## Access Compliance Report Public Rights-of-Way (Curb Ramps)

Intersection ID: 46033Main Street: DOMINION\_VILLAGE\_DRCross Street: SUMMER\_VALLEY\_CTLocation:SWADA ID: F19FBA50D49DRamp Type: PerpDiagInitial Pass/Fail: FailOverall Compliance: NoSeverity Score:10

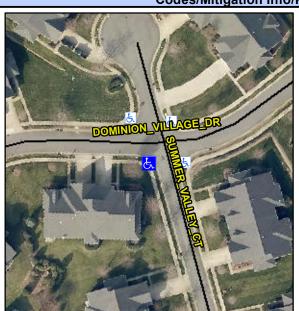
Not Found, R304.5.1, R304.5.3

Field Measurements/Component Compilance					
Compliance Description		Data	Compliance Description		Data
N/A	Ramp Length (in)	48.0	Yes	Ramp Slope (%)	5.9
No	Ramp Width (in)	38.0	No	Ramp XSlope (%)	2.7
N/A	Flare Type LT	N/A	N/A	Flare Type RT	N/A
N/A	Flare Slope LT (%)	N/A	N/A	Flare Slope RT (%)	N/A
N/A	Flare Traversable LT?	N/A	N/A	Flare Traversable RT?	N/A
N/A	Landing Length (in)	N/A	N/A	DWS Provided?	N/A
N/A	Landing Width (in)	N/A	N/A	DWS Contrast?	N/A
N/A	Landing Slope (%)	N/A	N/A	DWS Length (in)	N/A
N/A	Landing X Slope (%)	N/A	N/A	DWS Full Width?	N/A
N/A	Landing Curb? (Y/N)	N/A	N/A	DWS Offset (in)	N/A
N/A	Shared Landing?	N/A			
N/A	Gutter Ponding?	N/A	N/A	Gutter Slope (%)	N/A
N/A	Gutter Lip Ht (in)	N/A	N/A	Gutter X Slope (%)	N/A
N/A	Painted X Walk1?	No	N/A	Painted X Walk2?	No
	X Walk 1 Direction	To E		X Walk 2 Direction	To N
N/A	X Walk 1 Width (in)	N/A	N/A	X Walk 2 Width (in)	N/A
	X Walk 1 Slope (%)	9.0		X Walk 2 Slope (%)	7.2

X Walk 1 X Slope (%)	11.6		X Walk 2 X Slope (%)	8.4
N/A	Ramp inside XWalk1?	N/A	N/A	Ramp inside XWalk2?	N/A
	Road Slope (%)	4.0	N/A	Clear Space?	N/A
	Road X Slope (%)	11.3	N/A	Clear Space to XWalk (in)	N/A
N/A	Any Obstructions?	N/A	N/A	Storm Grate/Utility Hazard?	N/A
	Obstruction Type			Storm Grate/Utility Type	
		N/A			N/A
			Yes	Surface Condition? (G/P)	Good

Remove & Replace Curb Ramp With Two New Directional Ramps or Equivalent.
